ERCOUPE SERVICE BULLETIN NO. 34

ELEVATOR CONTROL HORN INSPECTION

DATE: January 4, 2013 Revision None

SUBJECT: Visual inspection of the steel elevator control horn and its mating aluminum channel for evidence of corrosion.

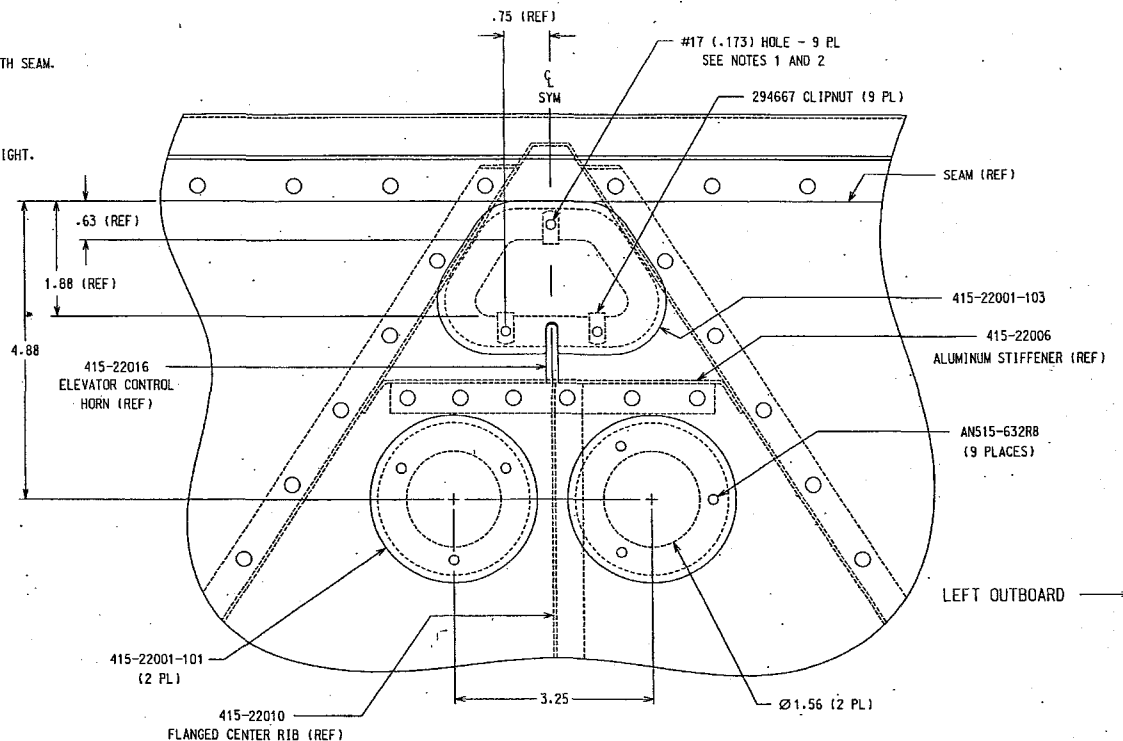
Univair has determined that two 1.56 diameter holes and one trapezoidal shaped hole located at the center of the bottom elevator skin will provide adequate inspection coverage of the attachment area of the steel elevator control horn. See Univair drawing 415-22013 INSP for layout dimensions of inspection holes.

The elevator should now be free to lift up and mark inspection access hole locations as detailed on drawing 415-22013 INSP.

4. Cut two 1.56 diameter holes in lower elevator skin aft of the aluminum stiffener per drawing 415-22013 INSP. Locate the inspection hole forward of the aluminum stiffener using template 415-22001-105, per drawing 415-22013 INSP. Locate and drill #17 holes as required.

7. If corrosion is found, repair and/or replace parts as necessary. Replacement parts are available for purchase from Univair.
8. When inspection is complete, install 294667 clipnuts and 415-22001-101 and 415-22001-103 plates over their respective openings and secure with MS35206-230 screws.

9. Connect elevator linkage to elevator horn.
10. Connect trim spring to elevator horn, if necessary.
11. Reinstall tail fairing assembly.
12. After this has been accomplished, with the elevator in its full down position, check clearance between the head of the MS35206-230 machine screws and the 415-31039 tail fairing. Verify that at least a .063 gap exists between the two.
